Interactive comment on “Assessing the potential hydrological impact of the Gibe III Dam on Lake Turkana water level using multi-source satellite data” by N. M. Velpuri and G. B. Senay

Author’s Response to Short Comment by M. Gebremicheal

Figure 2. Revised manuscript will be updated with Figure 2 on the left. Right: Existing figure 2 in manuscript

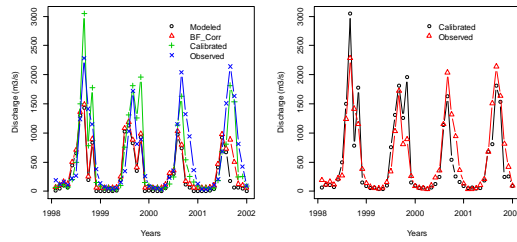
Comment #8: On Section 4.1: L 4 what do you mean by “initial comparison”? The whole paragraph is not clear. Which statements do refer to Fig 2 and which statements refer to elsewhere?

Author's response: We agree with the comment that section 4.1 is not clear. Actually, in published Figure 2, we showed only model calibrated vs. observed runoff data and removed un-calibrated runoff data to avoid the clutter. We would add un-calibrated and base flow corrected data to Figure 2 that would demonstrate the underestimation in the modeled runoff data and would also improve the explanation of figure 2 in Section 4.1. Further, we will re-phrase the text in section 4.1 to convey the message clearly. See below for a comparison of new figure and existing Figure 2 in the HESSD manuscript. The new figure shows model un-calibrated (black circles), base flow corrected (red triangles), model calibrated (green plus) and observed runoff data (blue cross).
